SUBJECT: **RESUBMITTAL COMMENTS LETTER**

PROJECT NAME: CALUMET PARK

PROJECT #2020120042

APPLICATION: MAJOR SITE PLAN #25950

LANDSCAPE PLAN
CALUMET PARK
MARION CO FLORIDA

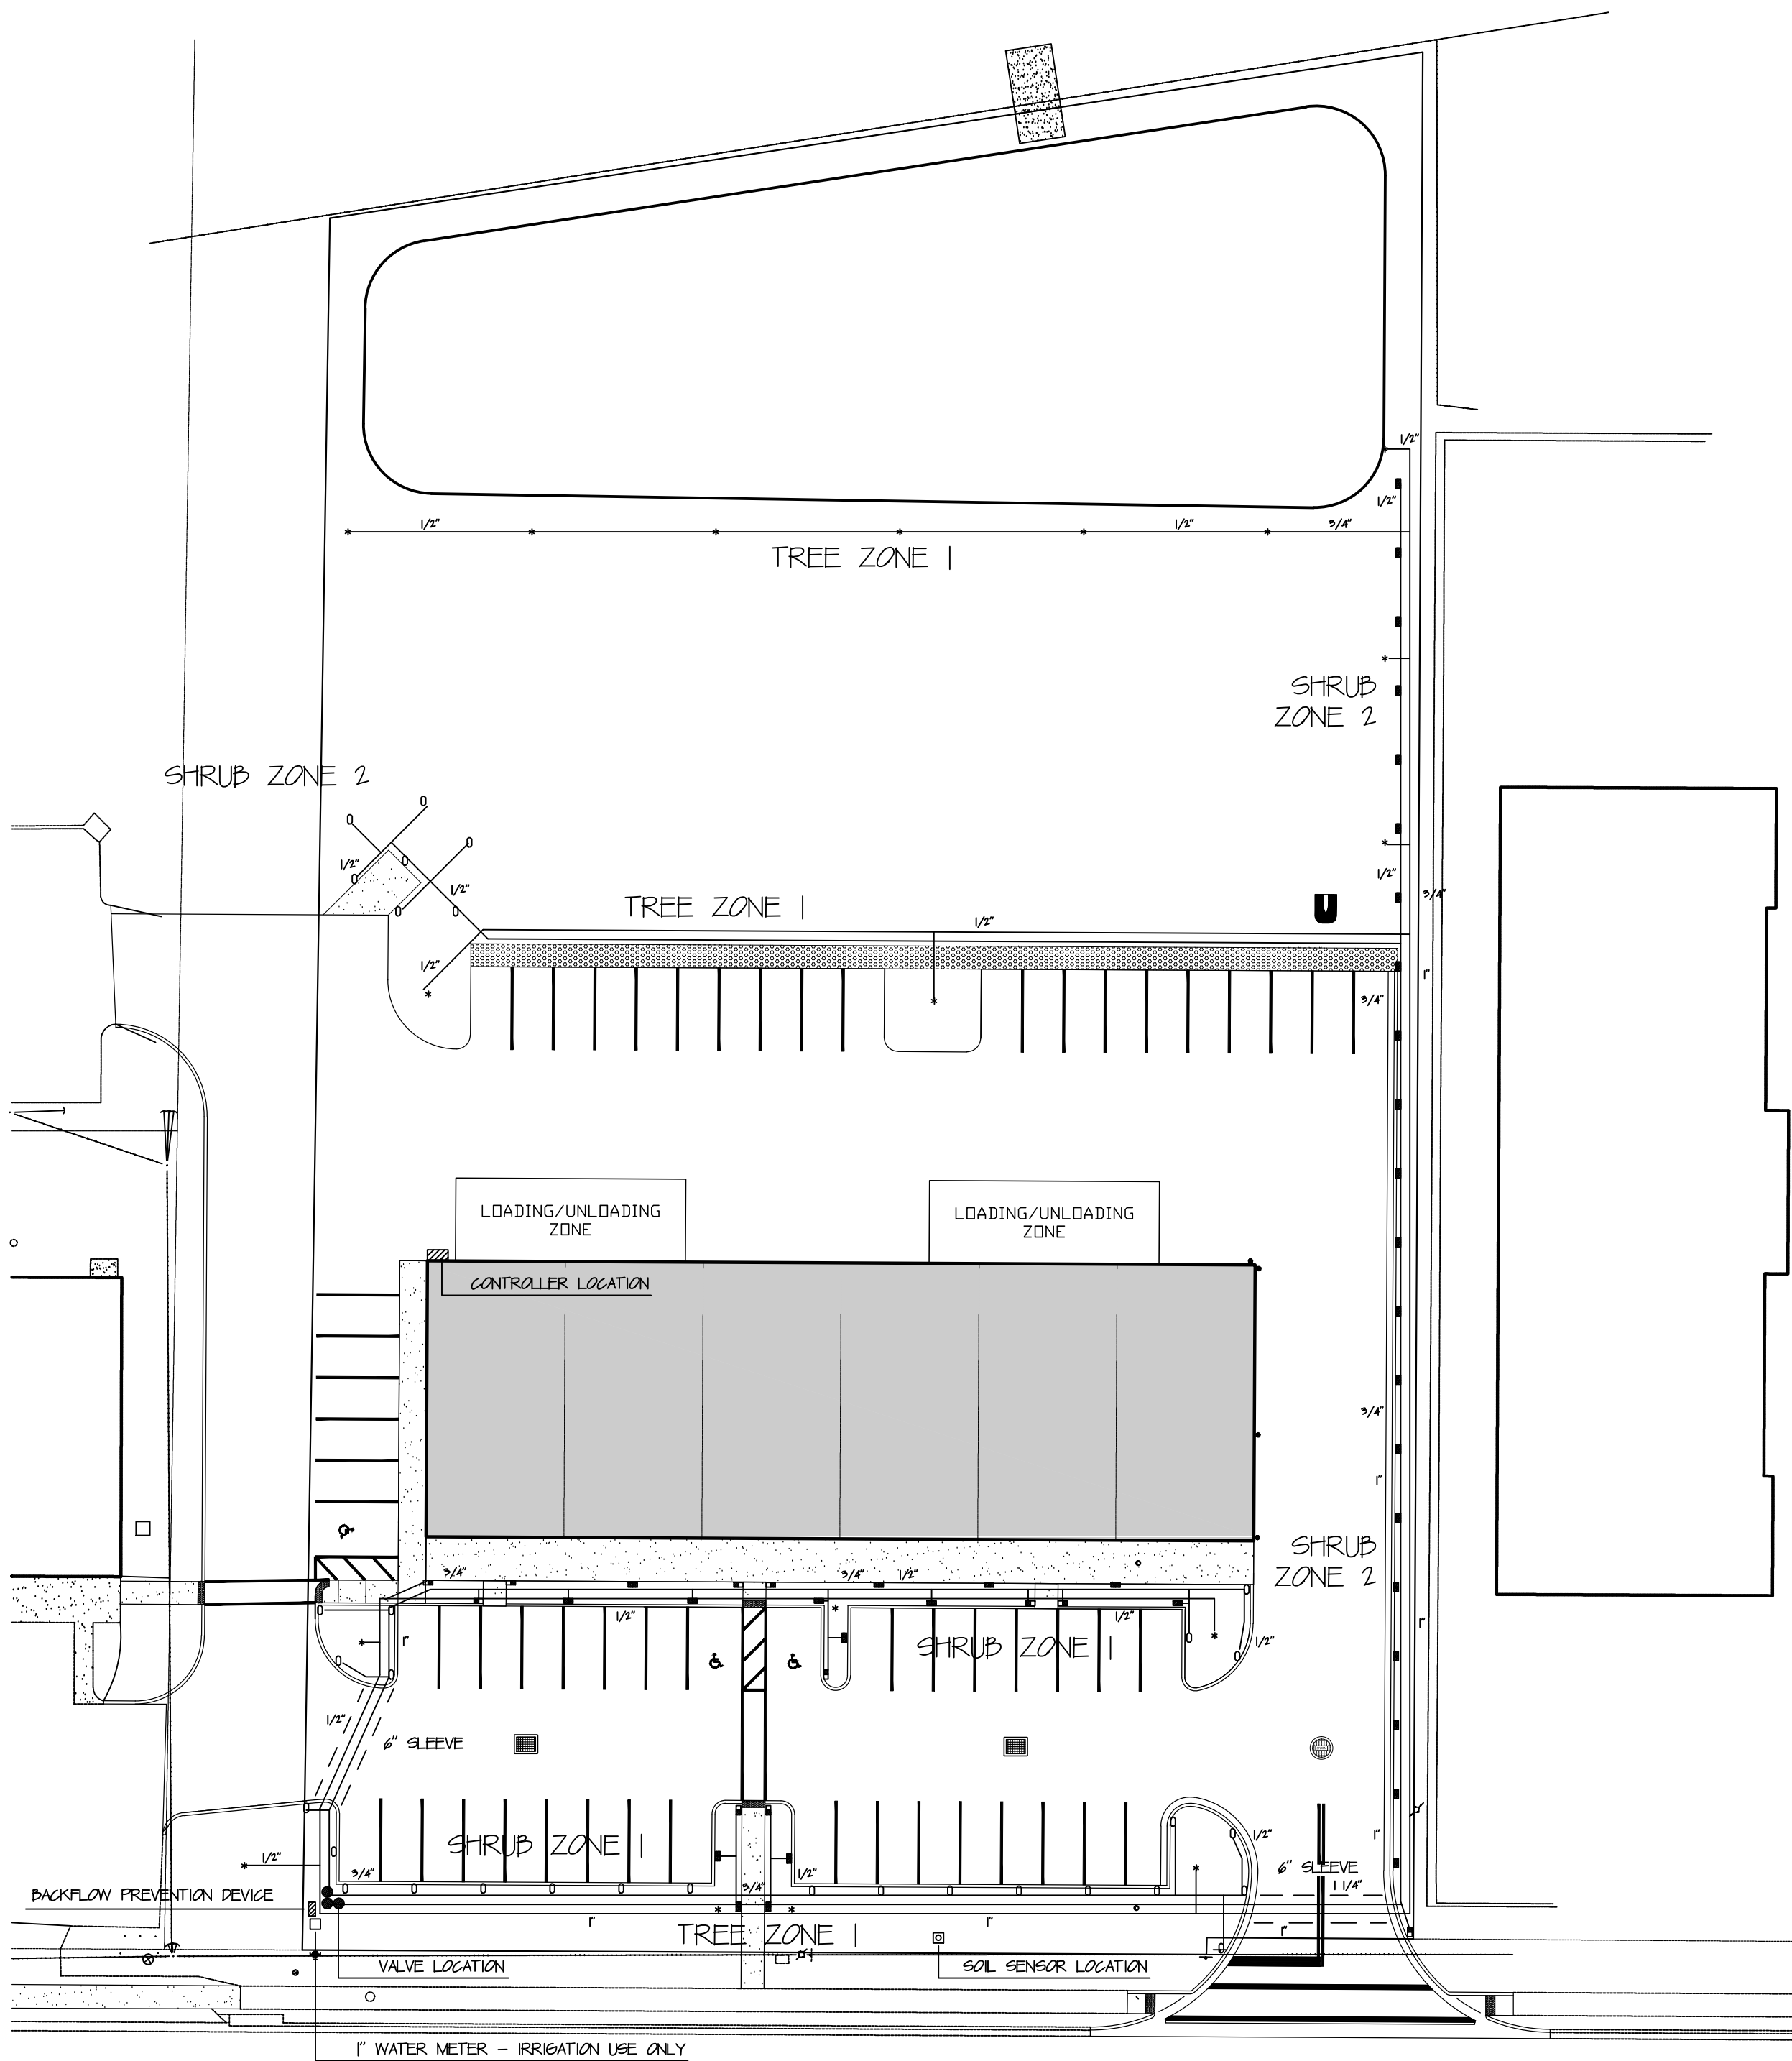
6. DEPARTMENT: 911 - 911 MANAGEMENT
REVIEW ITEM: 2.12.28 - Correct road names supplied
STATUS OF REVIEW: NO
REMARKS: Sheet L001 was not resubmitted so it still has an incorrect road name of West Silver Springs Boulevard. The correct road name is W HWY 40.

7. DEPARTMENT: LSCAPE - LANDSCAPE DESIGN AND IRRIGATION
REVIEW ITEM: 6.8.6 - Buffers
STATUS OF REVIEW: WAIVER REQUESTED. STAFF SUPPORTS.
REMARKS: Waiver required for ornamentals instead of shade trees along SR 40, staff supports

- LDC 6.8.6 - Buffers**
CODE states it is the intent of this section to eliminate or reduce the negative impacts of the adjacent uses upon each other such that the long term continuance of either use is not threatened by such impacts and the uses may be considered compatible.
APPLICANT requests waiver to allow ornamental trees for frontage buffer due to power lines.

Section & Title of Code: Section 6.8.6 - Buffers
Reason/Justification for Waiver Request: Allow ornamental trees for frontage buffer due to power lines.
